Access Compliance Report Public Rights-of-Way (Curb Ramps)

Main Street: N/A		Cross Street: ESPERANZA_RD		Location:	NW
ADA ID: RPAT210923141008	Ramp Type: Type 7 - Directional 2	Initial Pass/Fail: Fail	Overall Compliance: No	Severity Score:	15
Codes/Mitigation Info/Possible Solution			Field Measurements/Component Compliance

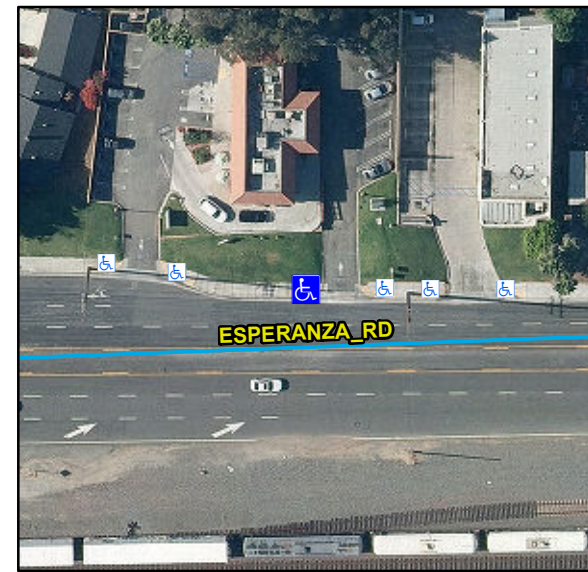
R304.2.2, STD 1115

Remove & Replace Entire Ramp.
